**ADDENDUM NO. 6**

TO PROSPECTIVE BIDDERS ON CONTRACT **PAT-774.176** – HARRISON CAR  
MAINTENANCE FACILITY – REPLACEMENT OF HCMF TRACK SLAB AND  
REHABILITATION OF PARKING LOTS AND ROAD PAVEMENT

Sketch SK-C151  
Addendum No. 6

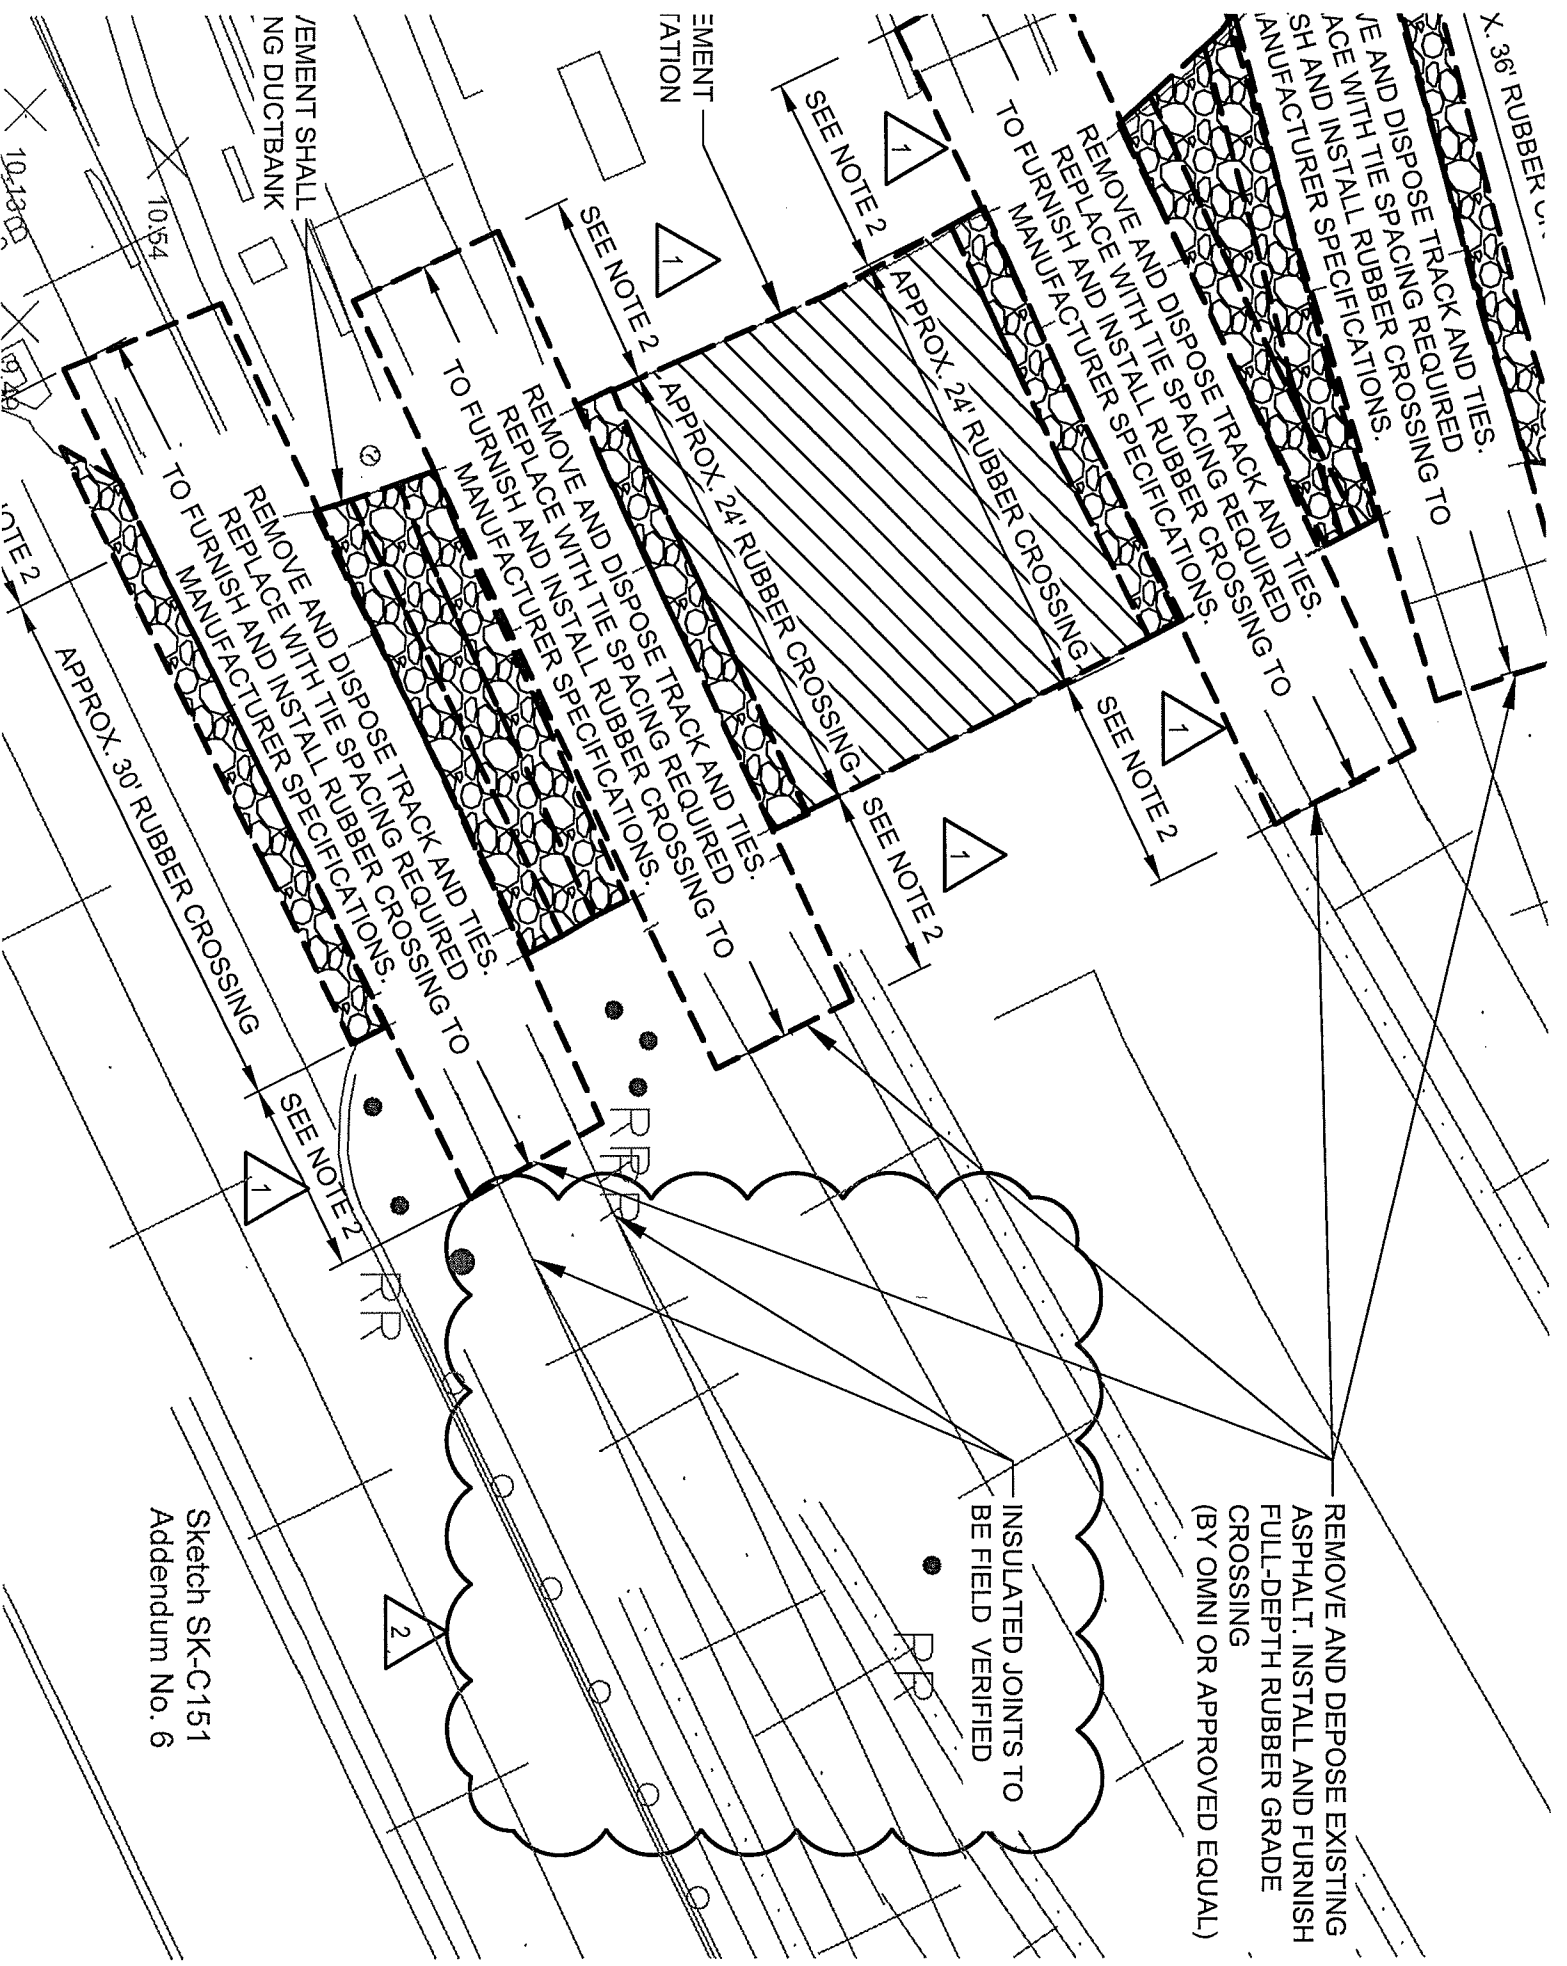
- Dwg. C101 - Immediately following the end of 3.01, insert the following new note:  
"4. TRACKWORK
- 4.01 PATH SHALL PROVIDE POWER AND SIGNAL  
REMOVAL, DISCONNECTIONS AND  
RECONNECTIONS."
- Dwg. C115 - Revise the drawing as shown on Sketch SK-C115 which is  
attached hereto and made a part hereof.
- Dwg. C125 - Revise the drawing as shown on Sketches SK-C125A and SK-C125B  
which are attached hereto and made a part hereof.
- Dwg. C151 - Make the following changes:
- A. Revise the drawing as shown on Sketch SK-C151 which is  
attached hereto and made a part hereof.
- B. Delete Notes 2 and 3 in their entireties and substitute therefor the  
following:
- "2. CONTRACTOR SHALL FURNISH AND INSTALL ALL  
TRACK MATERIALS TO 4 TIES BEYOND THE LIMITS OF  
CROSSING ON EACH END.
3. EXISTING RAIL IS 115 LB. UNLESS OTHERWISE FIELD  
VERIFIED."

1. SEE CONTRACT DRAWINGS NO. C201 AND C202 FOR PAVEMENT REHABILITATION DETAILS.
2. CONTRACTOR SHALL FURNISH AND INSTALL ALL TRACK MATERIALS IN KIND TO THE NEAREST JOINT BEYOND ROADWAY. CONSTRUCT TRACK IN ACCORDANCE WITH THE TYPE II TRACK REQUIREMENTS AS SPECIFIED IN SECTION 341111.

REMOVE AND DEPOSE EXISTING ASPHALT. INSTALL AND FURNISH FULL-DEPTH RUBBER GRADE CROSSING (BY OMNI OR APPROVED EQUAL)

INSULATED JOINTS TO BE FIELD VERIFIED

Sketch SK-C203  
Addendum No. 6

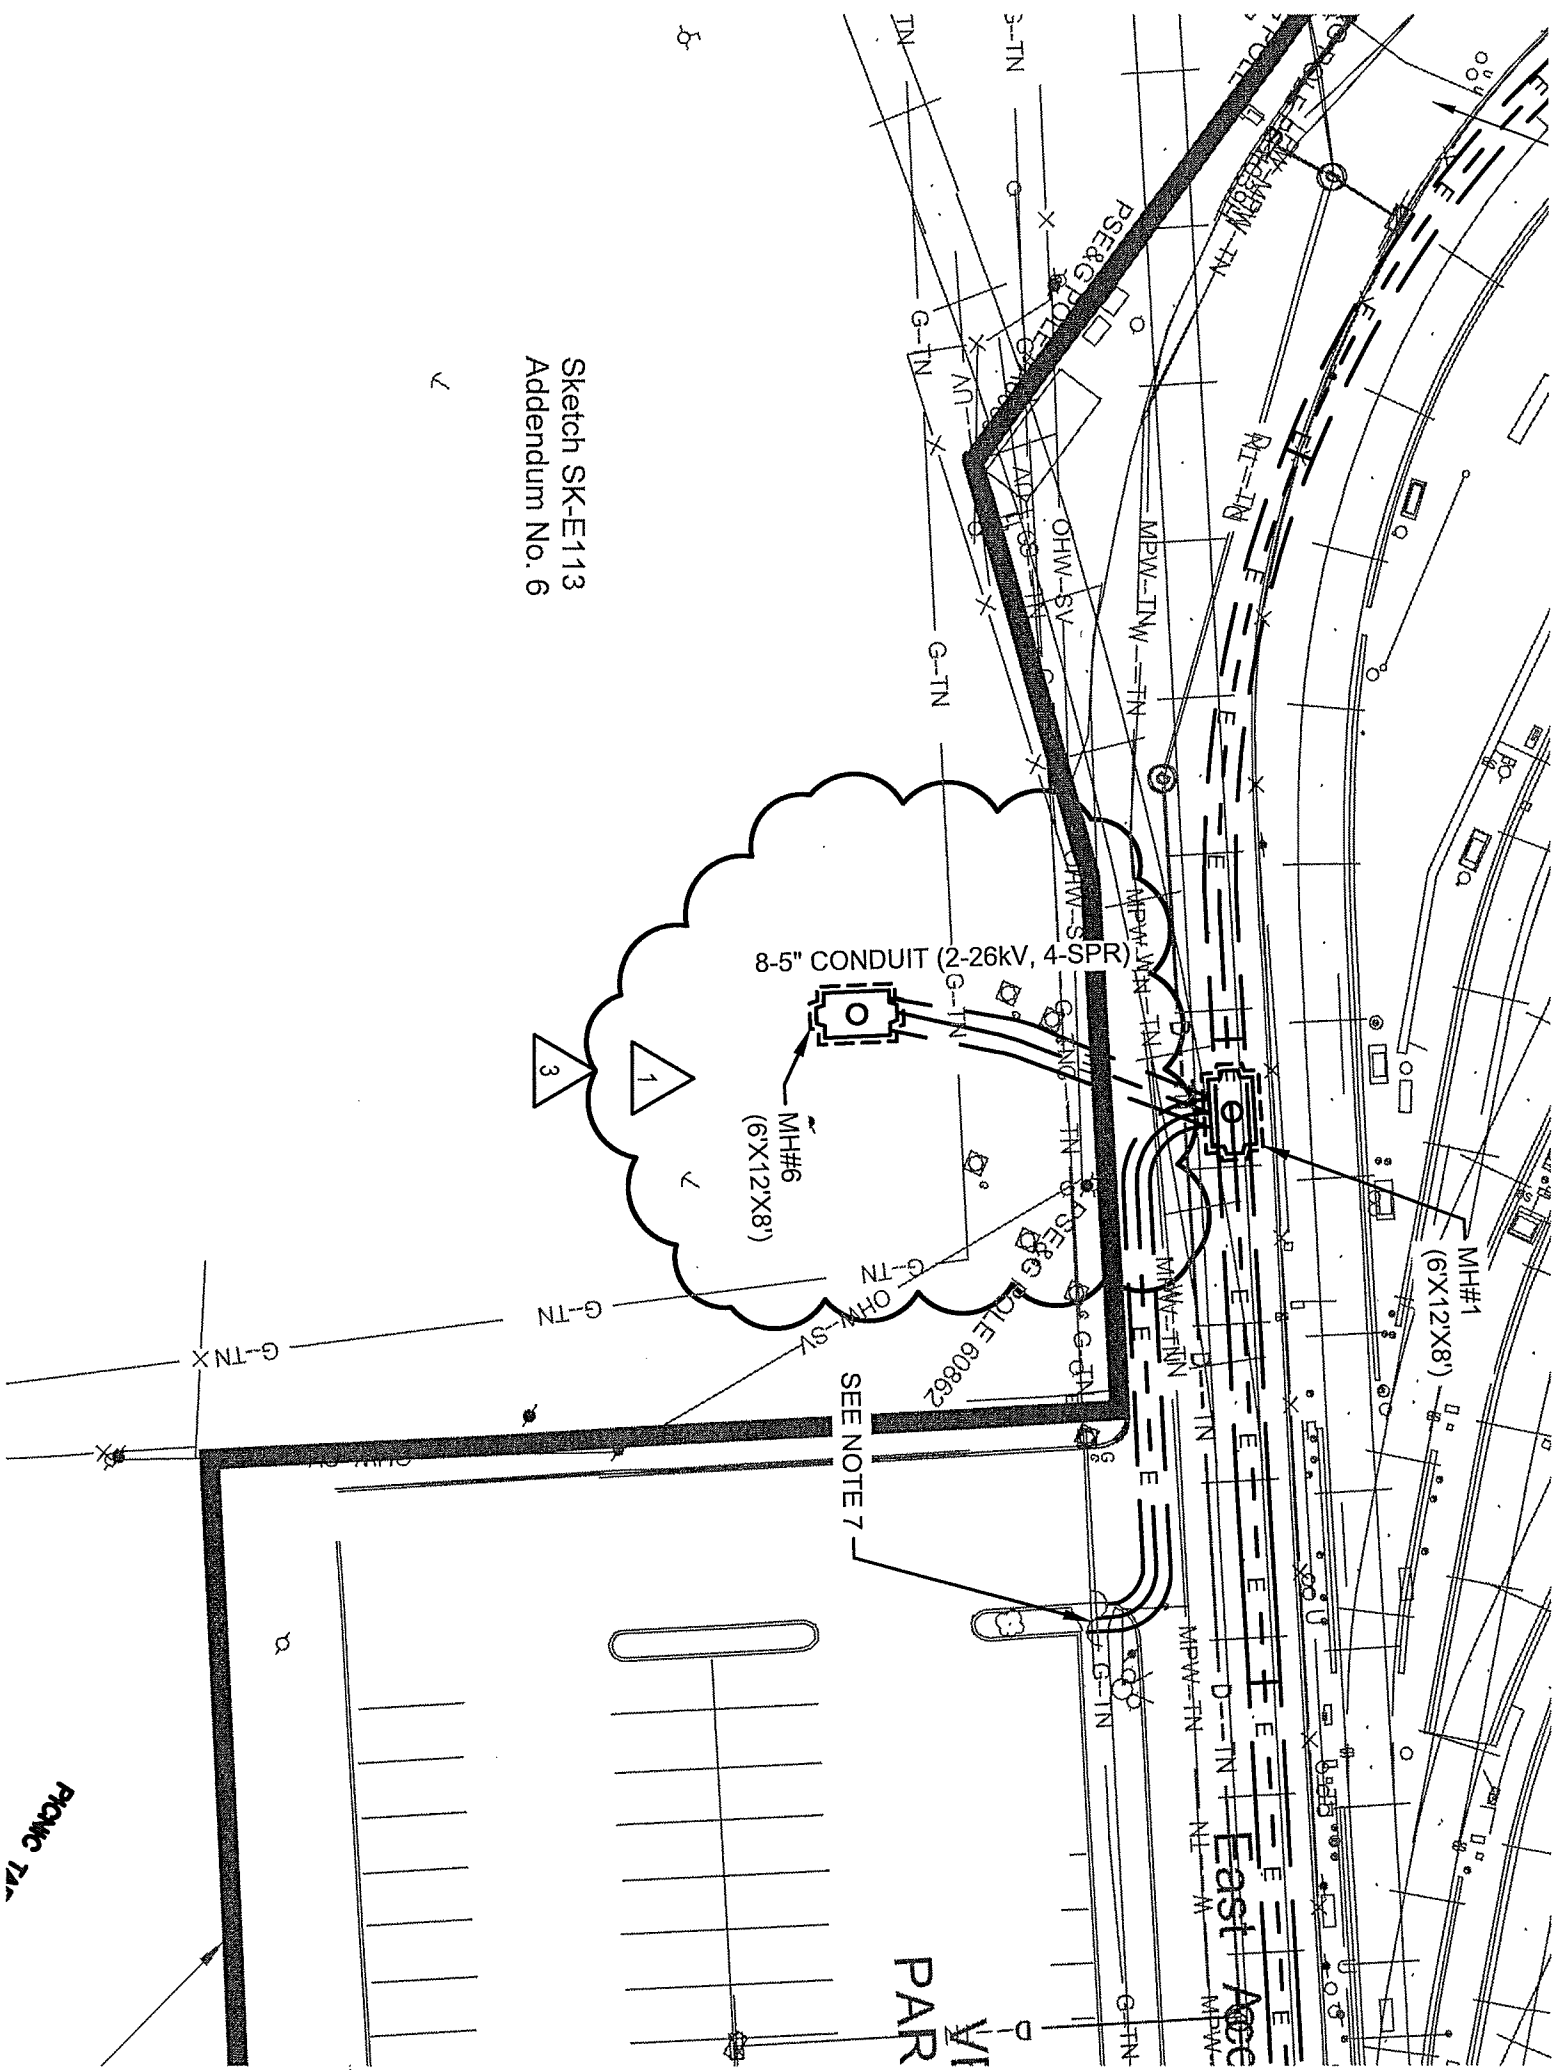
- Dwg. C203 - Revise the drawing as shown on Sketch SK-C203 which is attached hereto and made a part hereof.
- Dwg. E113 - Revise the drawing as shown on Sketch SK-E113 which is attached hereto and made a part hereof.
- Dwg. E119 - Revise the drawing as shown on Sketch SK-E119 which is attached hereto and made a part hereof.

1. SEE CONTRACT DRAWING NO. C151 FOR FULL DEPTH PAVEMENT LIMITS AT GRADE CROSSING.
2. CONTRACTOR TO FURNISH AND INSTALL ALL GRADE CROSSING AND TRACK MATERIALS.
3. CONSTRUCT TRACK AS SHOWN ON THIS DRAWING AND IN ACCORDANCE WITH THE TYPE II TRACK REQUIREMENTS AS SPECIFIED IN SECTION 341111. TRACK SHALL BE CUT-SPIKE ON AREMA TIE PLATES; BOX ANCHOR ALL TIES WITHIN THE CROSSING.
4. CONTRACTOR SHALL FURNISH AND INSTALL ALL TRACK MATERIALS TO 4 TIES BEYOND THE LIMITS OF CROSSING ON EACH END.
5. FURNISH AND INSTALL INSULATED JOINTS AS PER SPECIFICATION 341111.
6. REMOVE AND DISPOSE EXISTING RESTRAINING RAIL AND METAL FLANGEWAY WITHIN THE LIMITS OF THE GRADE CROSSING.
7. JOINTS SHALL BE JOINTED BARS UNLESS OTHERWISE FIELD VERIFIED.
